Revision : Issue-1
Date: 10th April 2022

Chorka Apparels Ltd.

Kazirchor, Danga, Polash, Narshingdi
(23.898113, 90.573466)

15th November 2021

Column C-3 in layout

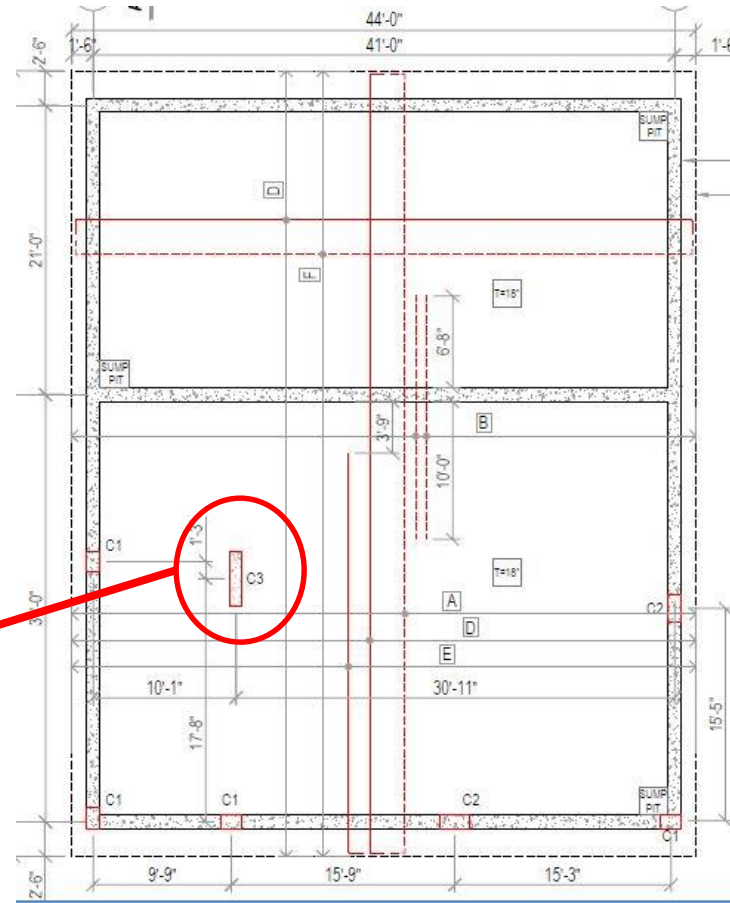
Column C-3 is shown as C-2 in schedule

Column C-3 is shown as C-2 in schedule.
Factory engineer is required to update the as-built drawing.

No vertical/horizontal bracing provided in wall and roof

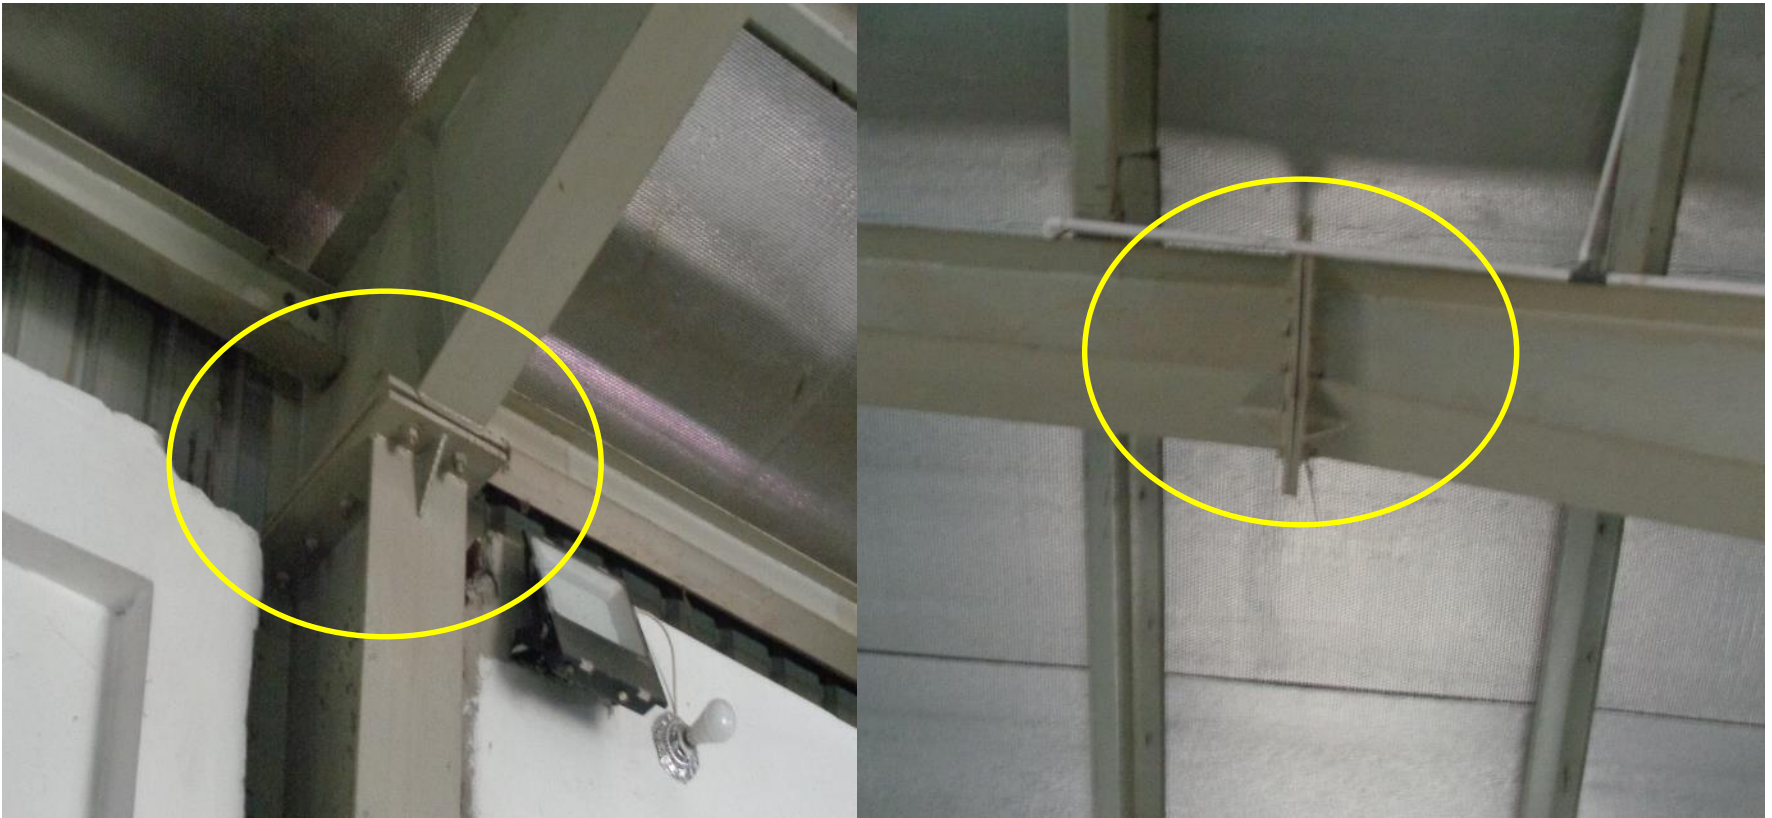
Only strut member along the long direction (eave level) is present but no bracing is provided in the roof and wall to resist the lateral loads. Therefore, stability system along long direction is incomplete. Factory engineer is required to check the lateral stability of the structure.

125mm thick isolated brick wall with high unsupported length

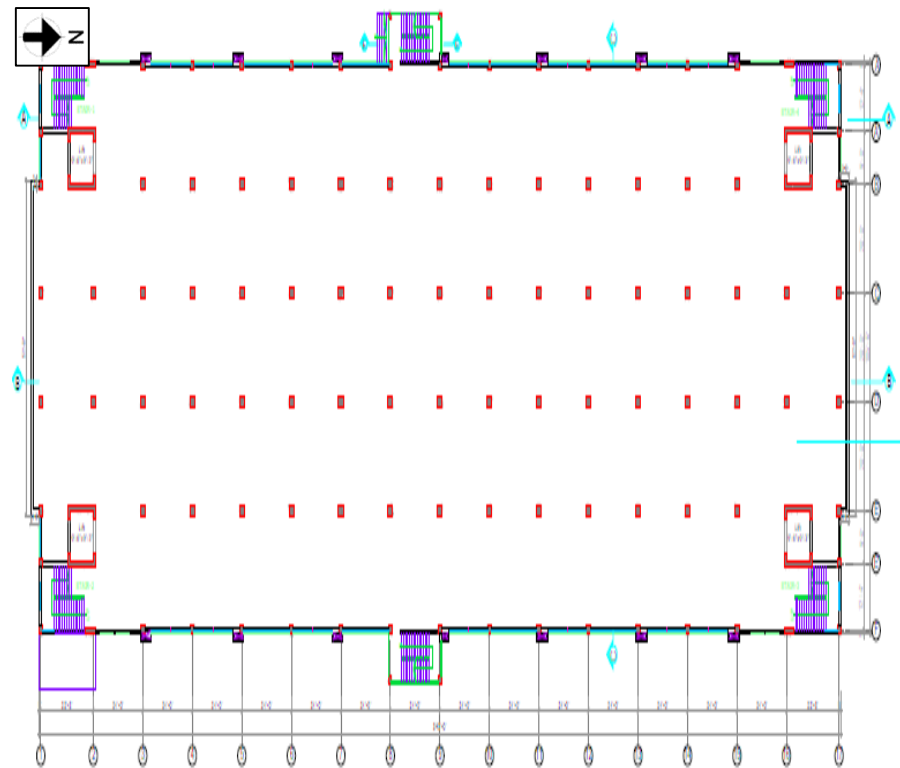
4.3 m high and 125 mm thick brick walls are standing between column spans without any connection with steel columns. Therefore, these walls were apparently laterally unstable. Factory engineer is required to check the lateral stability of the unsupported brick walls and implement necessary remediation measures.

Undocumented toilet block on typical floor

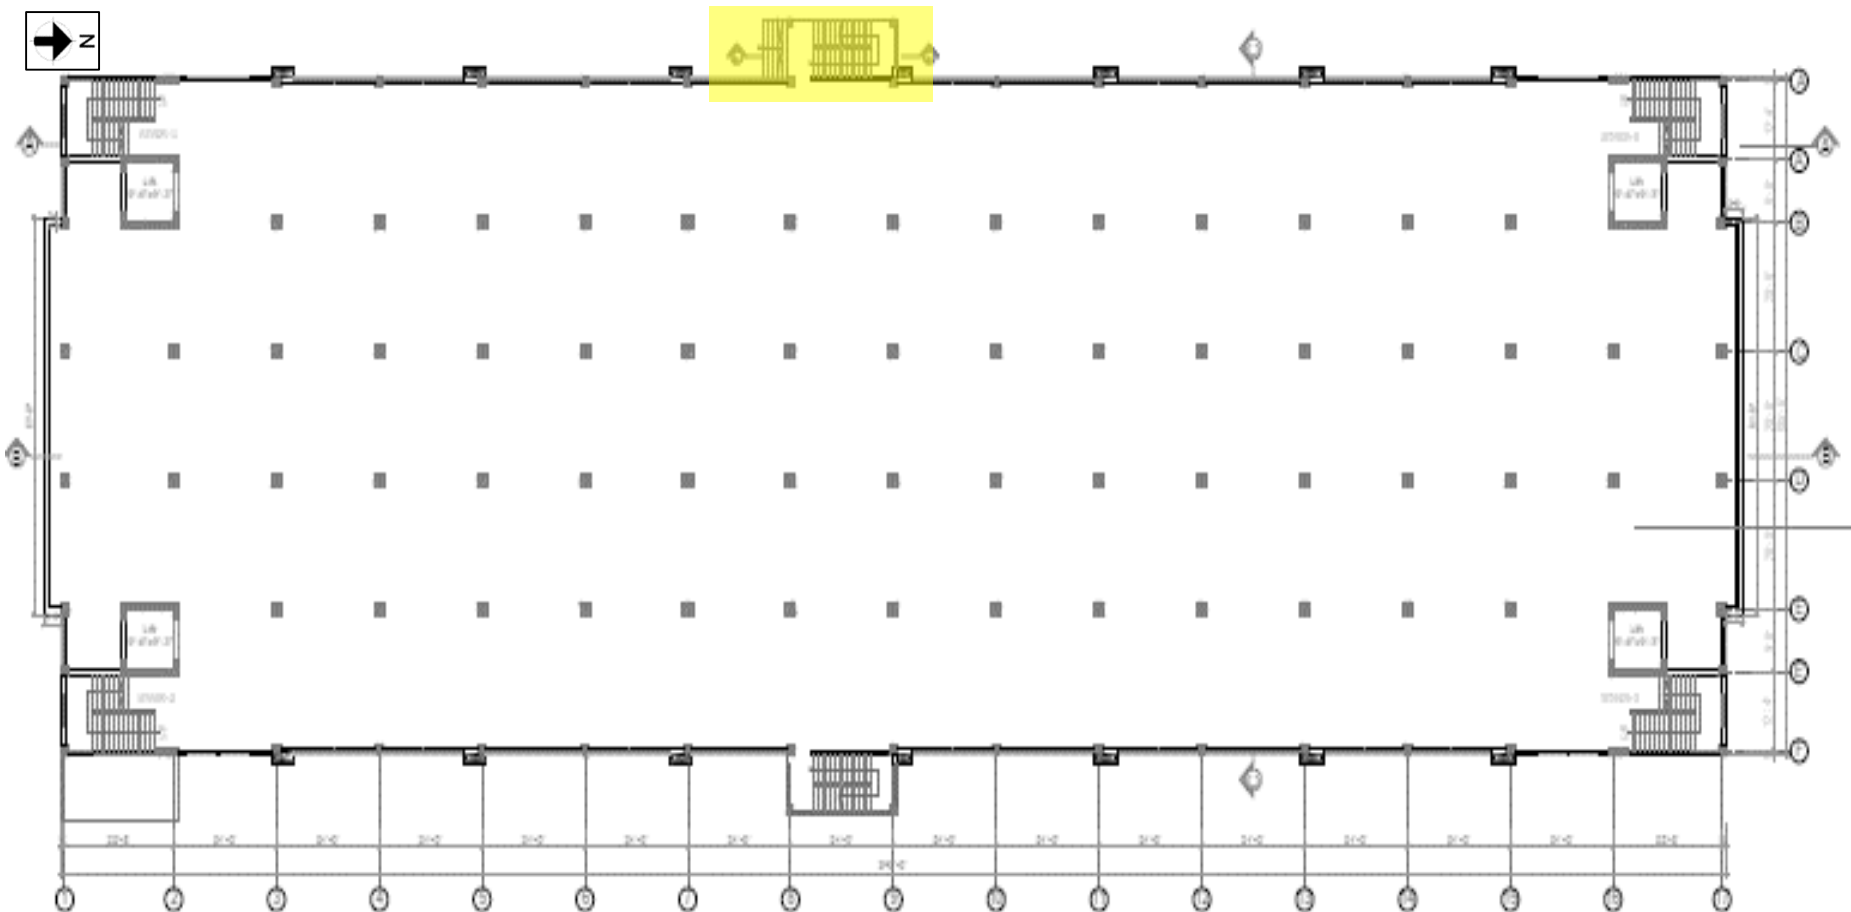
Cantilever slab at south and north side of 1F to 4F

Undocumented mezzanine and printing section at GF

Emergency stair at west side has not been constructed.

Newly built toilet block, cantilever slab (North & South side) not shown in as built drawings. Emergency stair at west side has not been constructed. The building engineer is required to survey the structure and produce accurate as-built drawings.

No roof bracings provided at roof

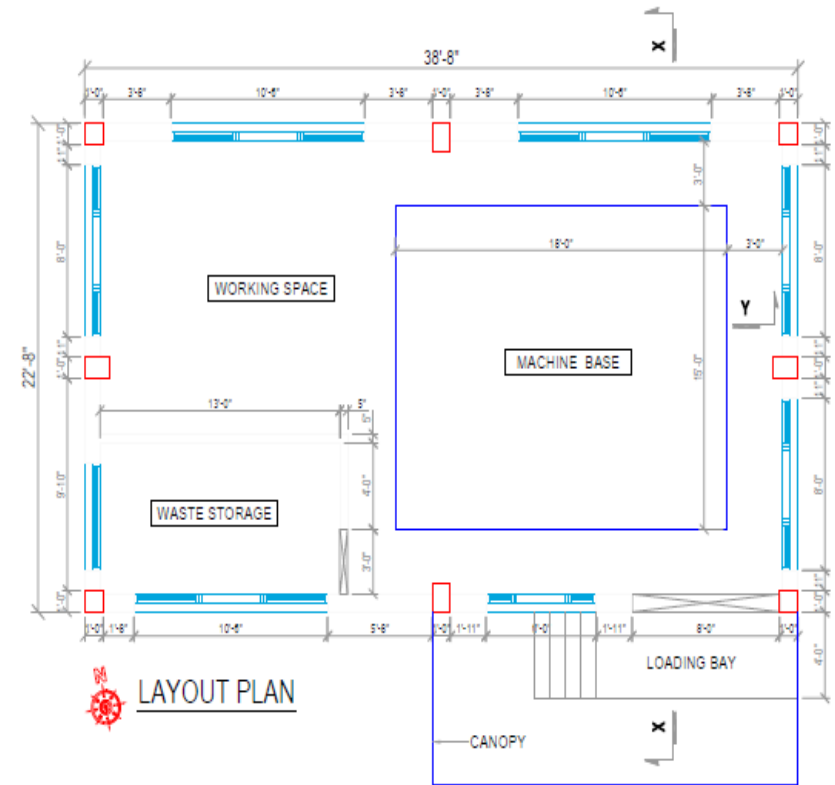
RC tie beam is provided along long direction (periphery only) but no bracing is provided at roof. Therefore, lateral stability of roof truss is apparently inadequate. Factory engineer is required to check the lateral stability of the structure.
